WATERLOO METRO QUARTER BUILDING 3&4

SSD-10437 - RESPONSE TO SUBMISSIONS
SUPPLEMENTARY DESIGN REPORT

PREPARED FOR WATERLOO DEVELOPER PTY LTD
DOCUMENT NO. WMQ-BLD34-BSA-AR-RPT-DA210

Revision A

13. Awnings

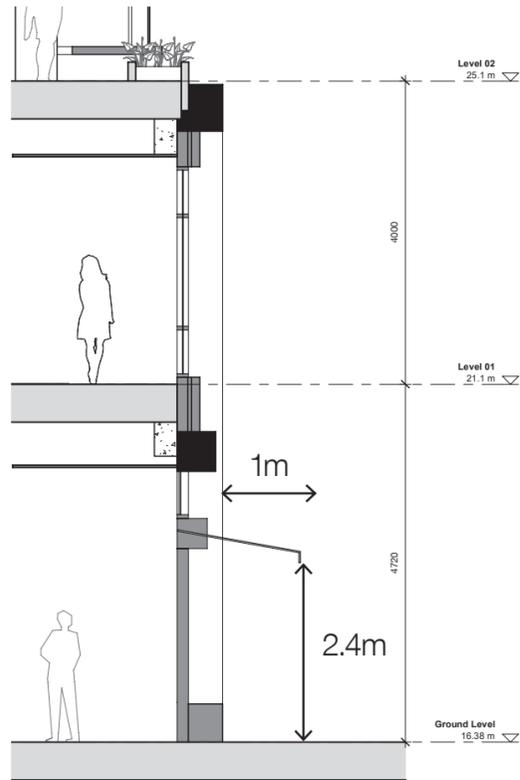
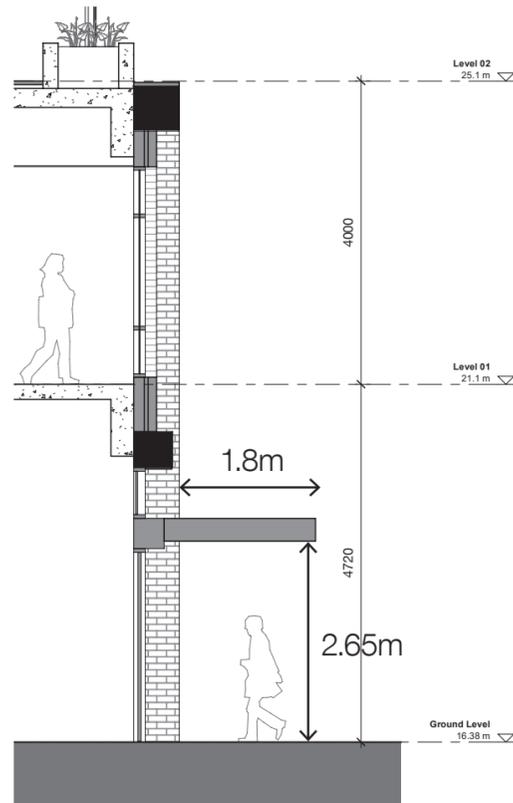
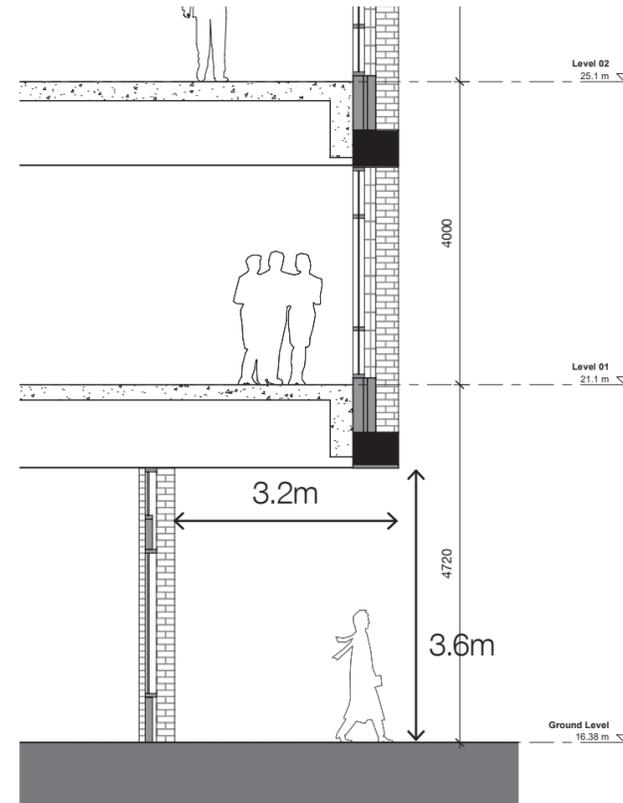
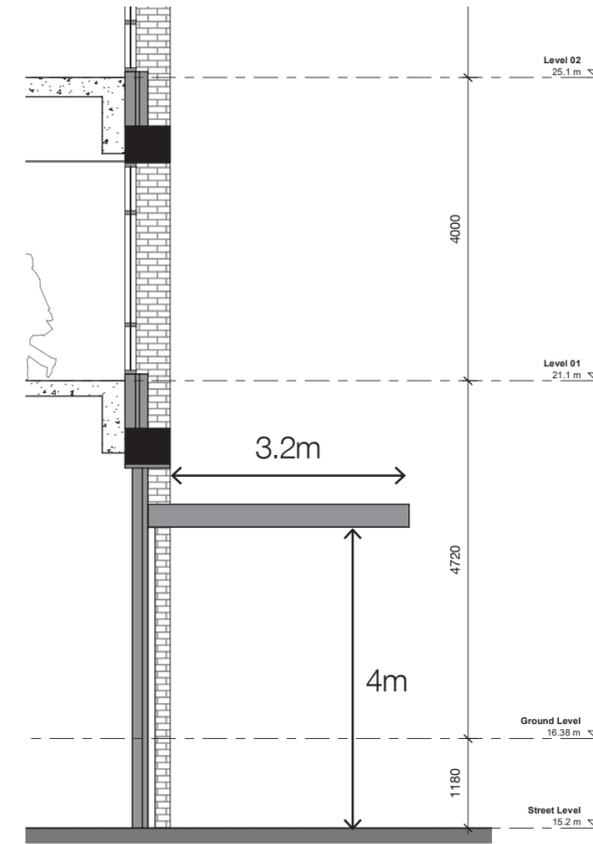
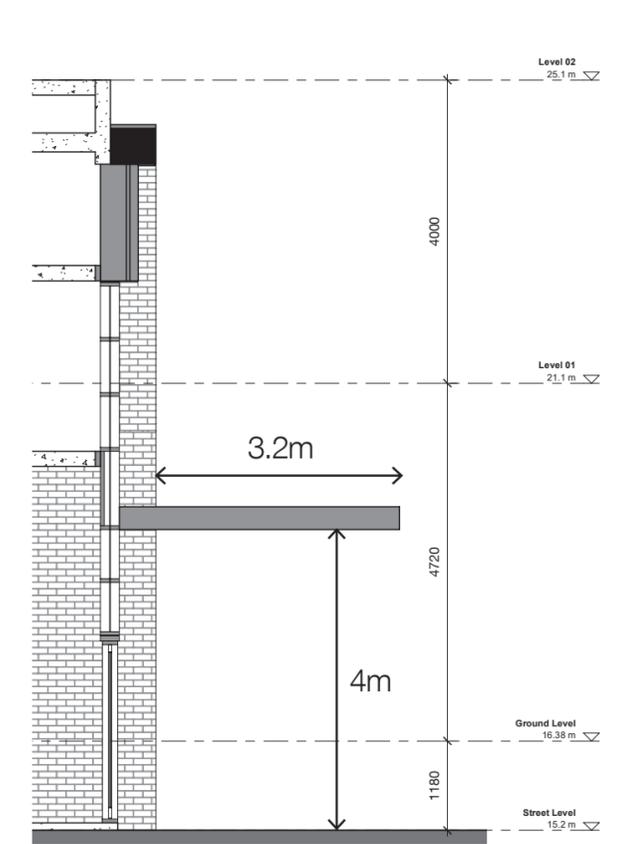
The applicant and DPIE are to ensure that all awnings located over the public domain and through-site links are to be between 3.2 metres and 4.2 metres above finished ground level and to be setback a minimum 800mm from the kerb. Awning widths are to be between 2 metres and 3.6 metres whilst remaining clear of smartpoles by 1 metre and street trees by 1.5 metres. This is to allow for under awning signage, provide suitable weather protection for pedestrians and provide sufficient clearance for vehicles, trees and infrastructure.

The design incorporates a variety of awning types to provide shelter from the elements in front of building entries.

/ The variety of awning types is consistent with the Urban Design principles for the precinct, Building 3 has an eclectic mix of awning types

/ Types C, D and E are consistent with the City of Sydney requirements

/ Types A and B are typically lower to create a more intimate scale to the community space. These awnings are located above an elevated terrace, as opposed to a typical street footpath, and therefore the City of Sydney control does not apply.

3D view of the east elevation showing the additional windows proposed to the south east studio

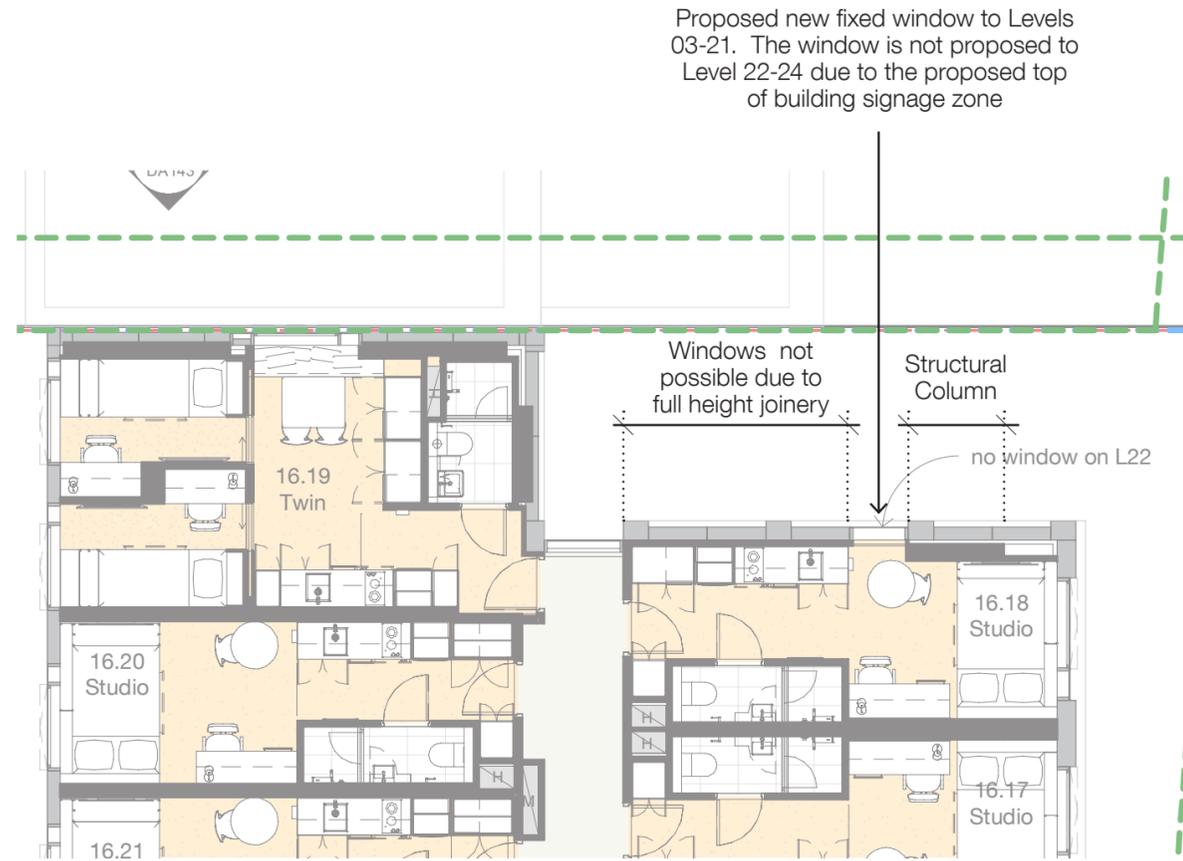
(a) Blank side walls – The north and east elevations of Building 3 feature large expanses of solid cladding. The east elevation is proposed to be clad in a moderately dark colour. The design would be improved by adding a window to the east wall of the studios in the SE corner on levels 6 and above. While the cladding is articulated into horizontal and vertical framing with infill panels, the materials for each of the elements is the same, resulting in monotony. This could be relieved by using alternate materials or textures for the infill panels; (City of Sydney)

Additional Window to the SE Studio

In response to the City of Sydney comments, an additional window is proposed to the south east studio on the eastern elevation.

This window will help break up the solid cladding to this elevation, whilst also providing solar access and easterly views to this corner studio.

3D facade section of the west facing facade

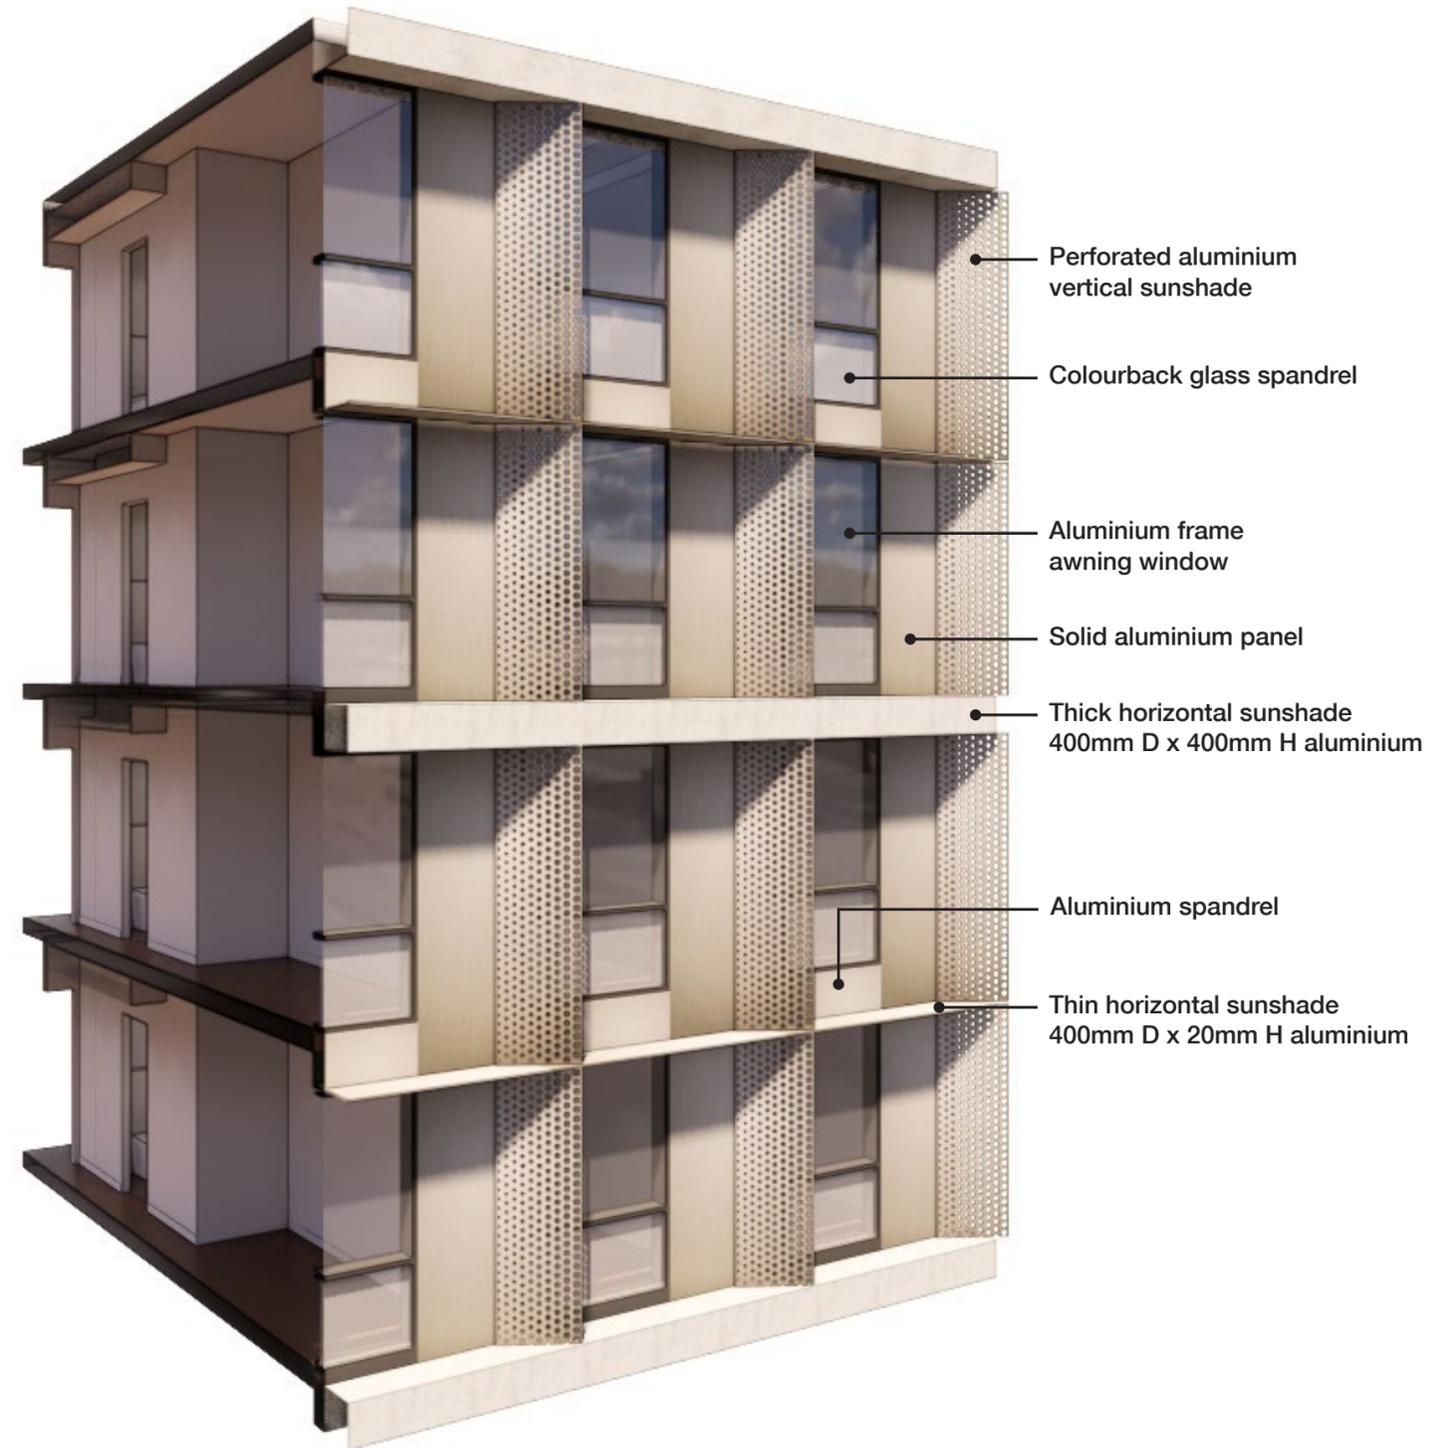
While it is acknowledged that the design includes some elements for shading to the western frontage, the current measures are not considered to properly address the building's exposure to direct western summer sun and urban heat considerations. Ideally, the west facade should be capable of providing close to 100% shading on extreme heat days. This can only be balanced with the requirement for midwinter sunlight ingress through the provision of externally mounted, individually operable shading devices, allowing students the ability to control heat themselves. The use of occupant-operated external blinds would also alleviate the monotony of the building expression by creating a dynamic facade, where each 'unit' of the facade would take on an individual appearance depending on the position of the louvres. This improvement could be achieved through a condition of consent and the City is able to provide the wording upon request. (City of Sydney)

The design of the western elevation has been developed through the DRP process to create a highly articulated facade that responds to the western sun.

Individually operable shading devices were considered, but were deemed not practically viable for student accommodation for ongoing maintenance and management reasons. Due to the high cost of individually operable devices, fixed shading was considered to be more cost effective solution to shading the building.

/ The western elevation has a high degree of solidity - the extent of glass to the west elevation is approximately 32%- (i.e the elevation is 2/3 solid)

/ An insulated colourback glass spandrel at lower level further reduces the area of vision glass

/ The west facade has a considered response to shading with horizontal sunshades for the early afternoon sun and vertical shading for the middle/late afternoon sun. As shown in the plan below, the vertical shading panel extends in front of the window to further assist in shading

/ All studios will be fitted with an internal pull-down roller blind for students

/ Performance double glazing to reduce heat transmission
